REFERENCE: RECON 26/0123

PROPOSAL: PROPOSED RE-DEVELOPMENT OF THE FORMER TRANSPORT YARD CORPORATION ROAD NEWPORT, PHASE 2 COMPRISING OF 14 RESIDENTIAL UNITS WITH ACCESS ARRANGEMENTS, PARKING AND ASSOCIATED WORKS

RECOMMENDATION: REVISIONS REQUIRED

Countryside and Conservation Landscape Comments

2. Boundaries

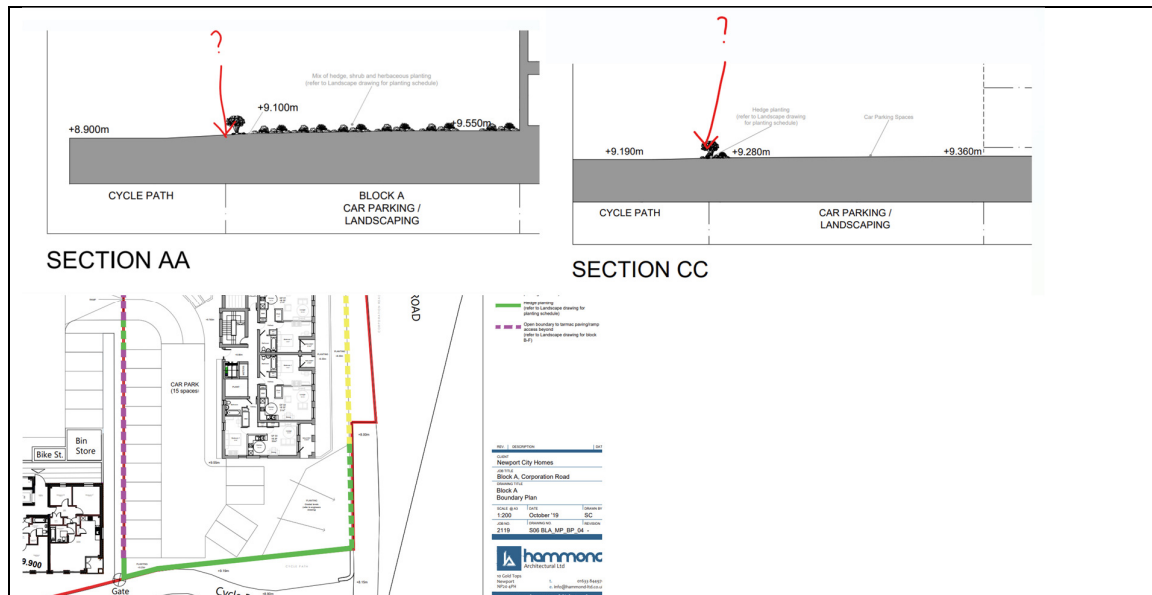
- A boundary plan has now been submitted.
- The boundary onto the cycleway appears to be the Portuguese laurel hedge, should there not be a low railing to highlight the **boundary between public and semi-private space**? There is likely to be a desire line from car parking onto cycleway.

3. Trees

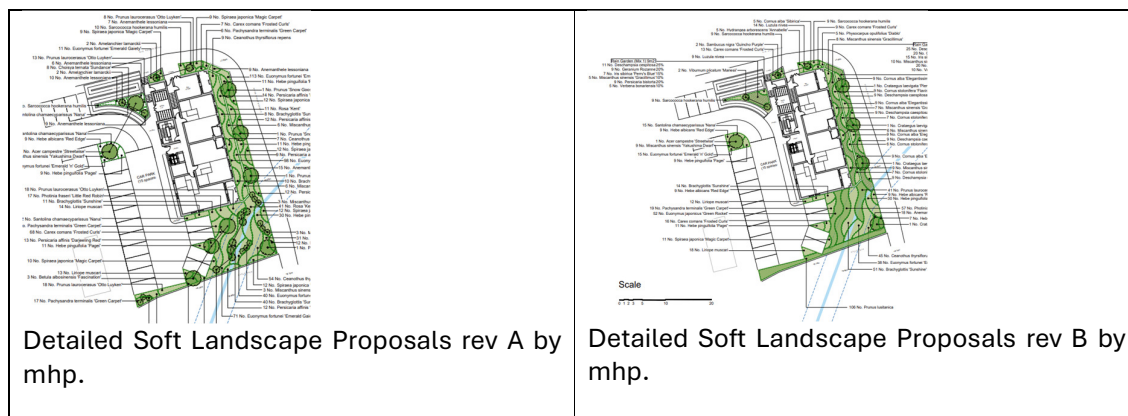
Rev B hedge proposal to the south is welcome although this will be a monoculture for the 25 liner meters + shown.

Rev B shows a reduction in tree planting to the south with no rationale – my comments were that the scheme was ornamental across a large area which will require skill to maintain, I had no issue with the trees which will provide much needed height to visually balance the multi-storey building and **strongly advise this change is reviewed**. Note that nine trees were previously shown now reduced to five.

- As previously the **nursery stock for trees is undersized** at 12-14cmg. I would recommend semi-mature stock of 16-18cmg or larger for early impact.
